City of Carlisle, Iowa  
Planning and Zoning Commission  
Regular Meeting  
March 15, 2021  
7:00 P.M.  
Carlisle City Hall

RE: **Danamere Farms Plat 10 – Construction Plan Review**  
**Carlisle, Iowa**  
*FOX Ref No: 8666-03C.259*

FOX Engineering has completed the second review for of the Danamere Farms Plat 10 (formerly Danamere Plat 9) Construction Plans, dated March 10, 2021 and offer the following comments:

# DANAMERE PLAT 10 CONSTRUCTION DRAWINGS

DANAMERE FARMS PLAT 10  
CONSTRUCTION DRAWINGS

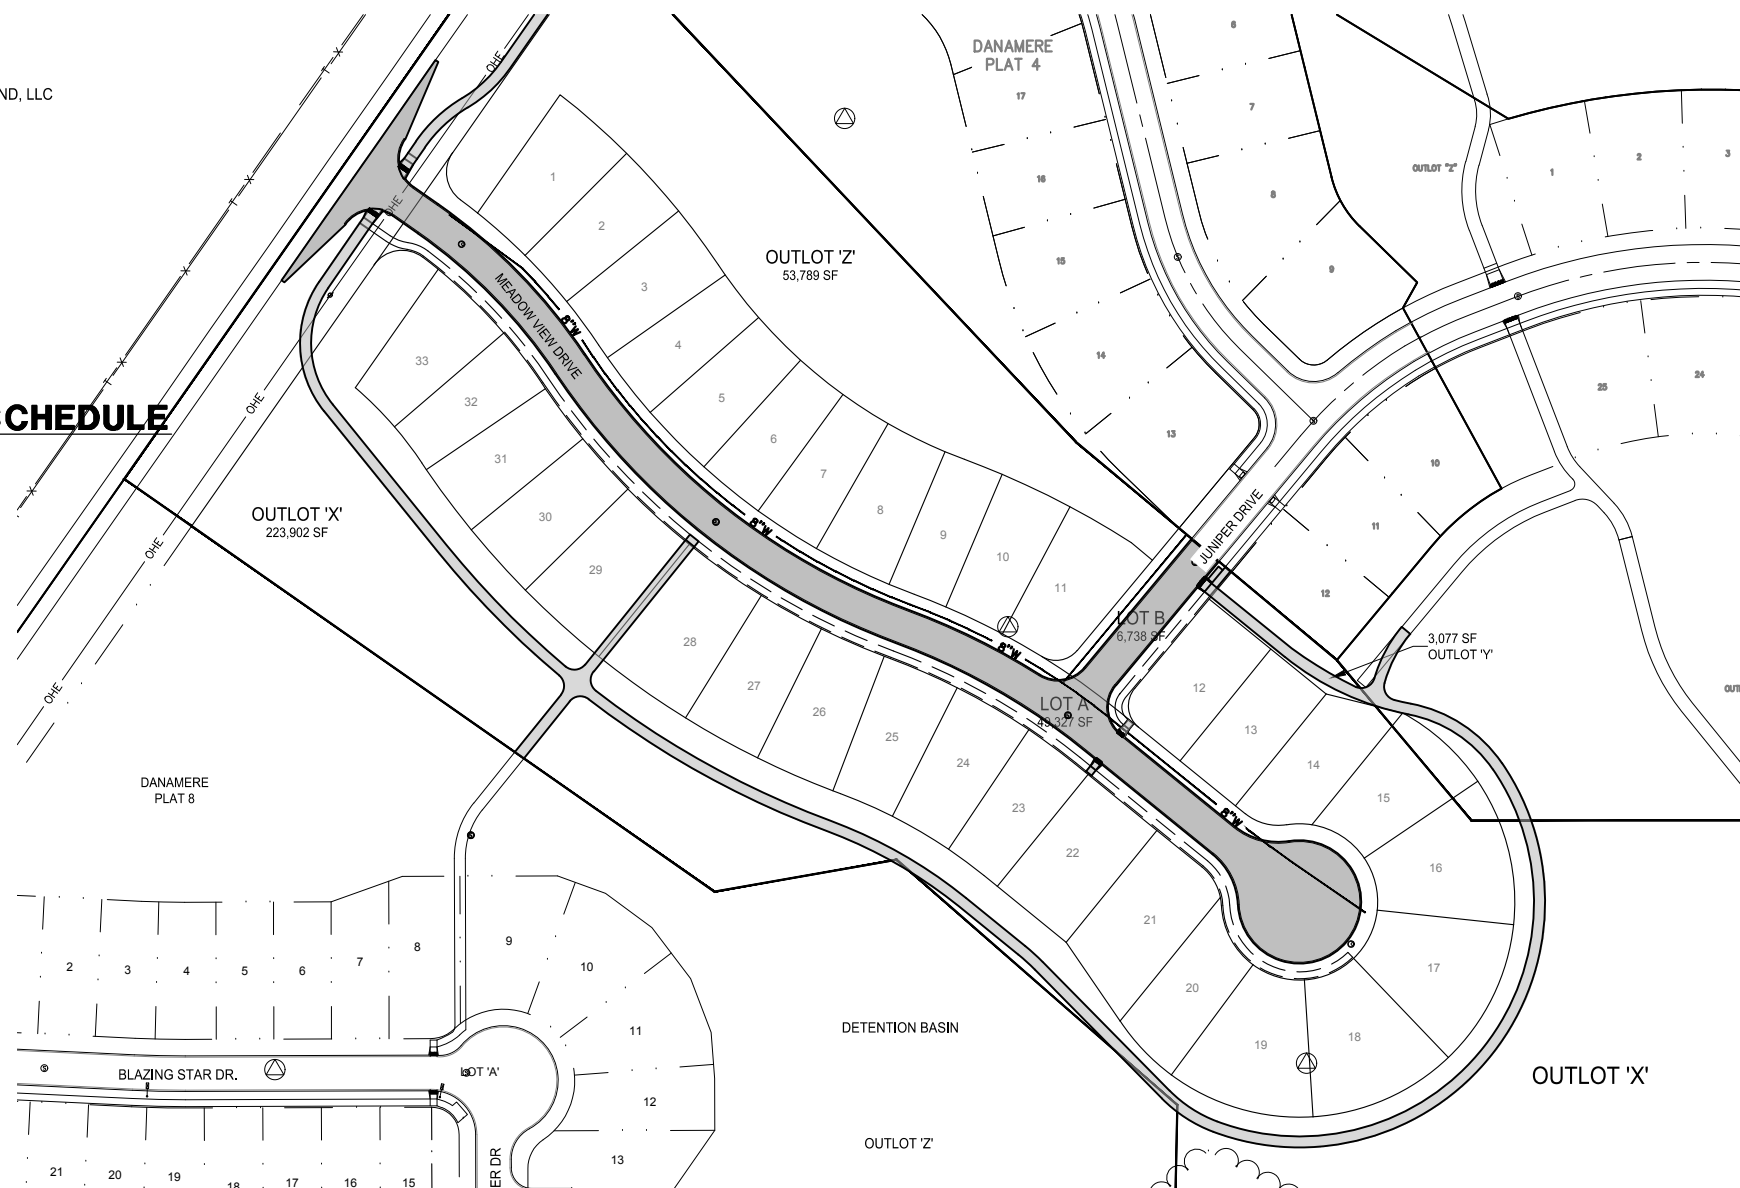
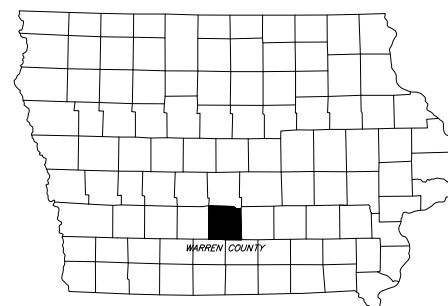
**Sheet 1 – Cover Sheet**

3. Please rename the planset to be “Danamere Farms Plat 10”.

**GENERAL LAYOUT & DIMENSION PLAN**

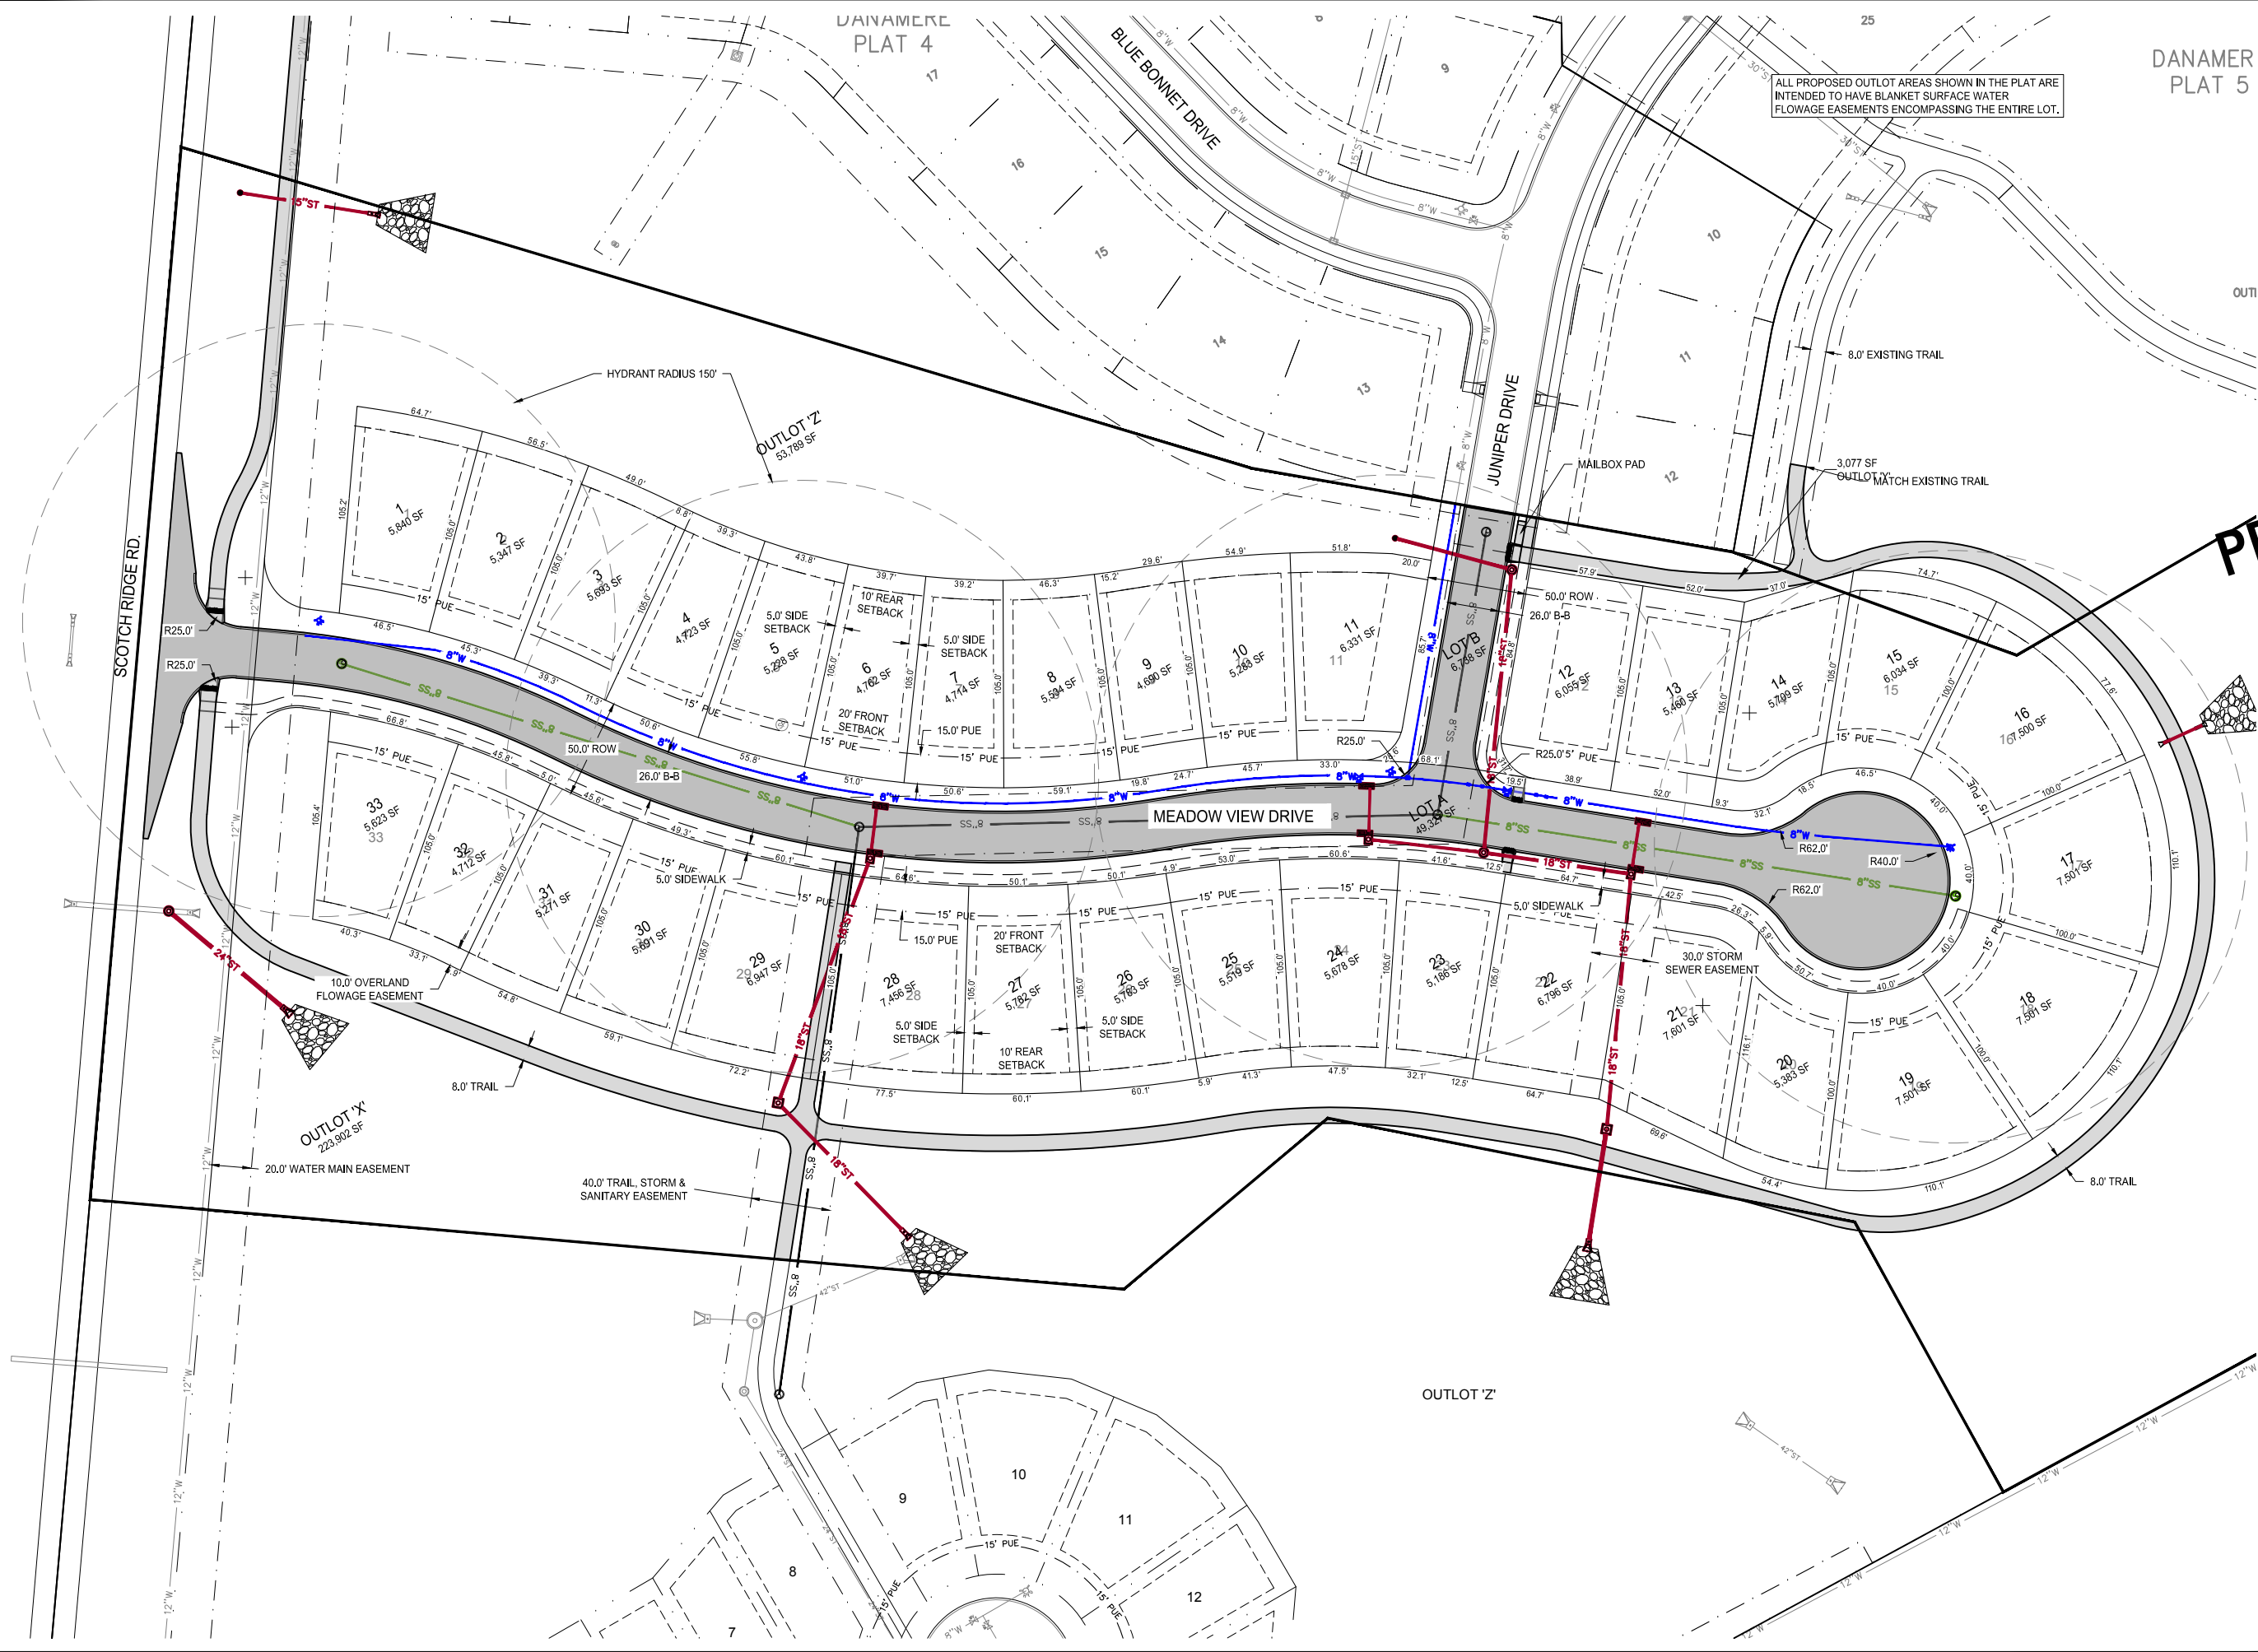
**Sheet 4 – General Layout and Dimension Plan**

5. Please pan the view port north to see where the new trail connects to the exiting trail along Scotch Ridge Road.
6. Please match the provided cul-de-sac labels to the new cul-de-sac linework.
7. Please show the water/sanitary sewer service locations for the plat, including where they will be installed along the cul-de-sac. This linework doesn't necessarily need to be shown on this sheet, but should be shown somewhere on the drawings, and especially on the plan/profile sheets.
8. Please provide an overland flowage easement for the overflow between lots 21 & 22.
9. Please review the location of the mailbox cluster with the Postmaster.

**GRADING PLAN & EROSION CONTROL**

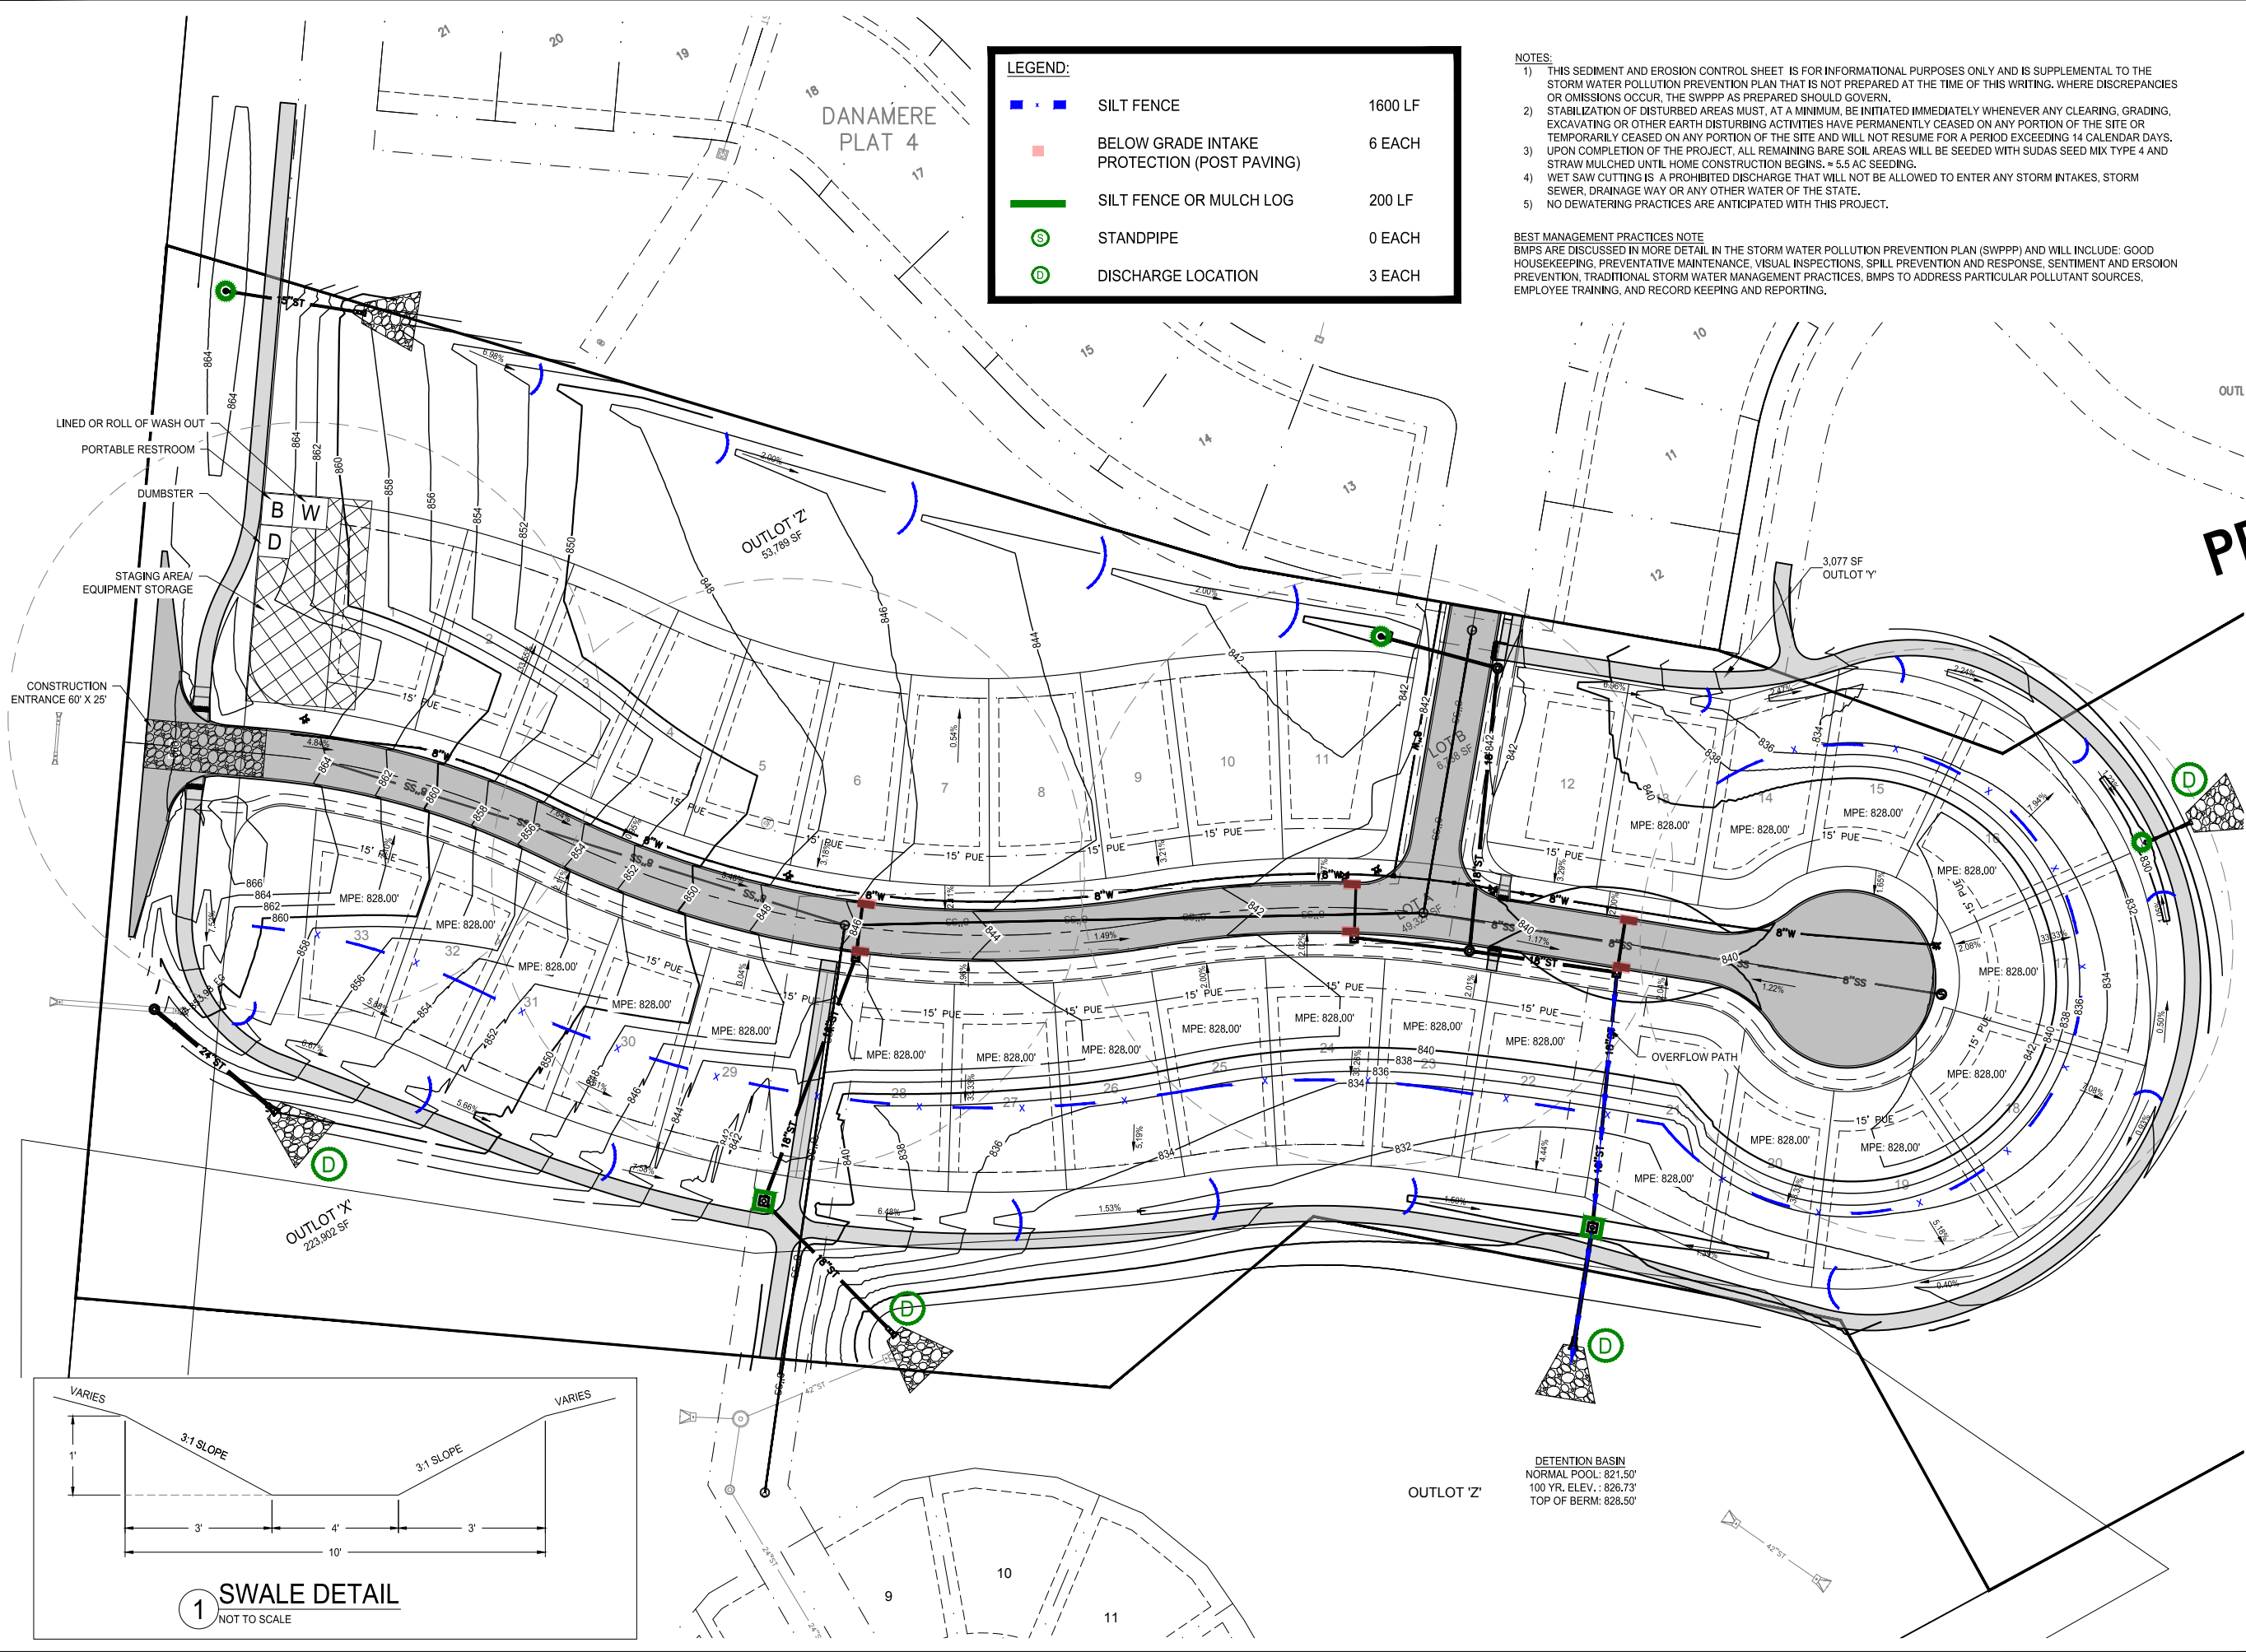
**Sheet 6 – Grading Plan**

10. It appears that the grades at the rear of Lots 18, 19, 20 & 21 are quite flat. Typically, any swale grades less than 1.5% should have subdrains to properly drain grass areas. Please revise the grading plan as necessary to increase grass swale longitudinal slopes above 1.5% or provide subdrains to help dry out the flat swales. Please review the rear of Lot 16 as well.

11. Please review the back yard grading of lots 9-11 and whether MPEs are necessary. Please review the grading of the adjacent plat (Plat 4) to verify whether there is risk of flooding to the adjacent property based on spillway elevation.

12. Please note at what elevation the spillway is for the intake in the rear of Lot 11, in the rear of Lots 16/17, in the rear of Lots 21/22, and the rear of Lot 29. Once again, MPEs should be 1-ft higher than the spillway elevation and/or highest water elevation (100-yr).

13. Please show the adjacent plat existing contours on this sheet.
